Office Action Summary

10/593,679

EVERTZ, EGON

DETAILED ACTION

Reproduced from Stubler (amended)

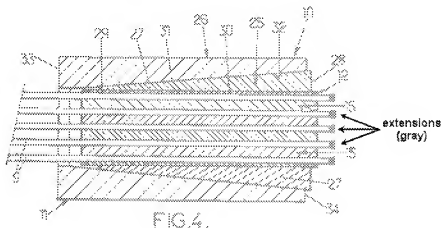
12. Regarding claim 7, Muller/Stubler as modified above discloses a building protection system with conical clamping body, with Stubler further disclosing wire cable extensions comprising strip-like bodies (amended Fig. 4).

- a. The examiner notes that the gray portions in Fig. 4 are considered the extensions of the wire.

13. Regarding claim 8, Muller/Stubler as modified above discloses a building protection system with conical clamping body, with Stubler further disclosing extensions having a continuous broadening (amended Fig. 4).
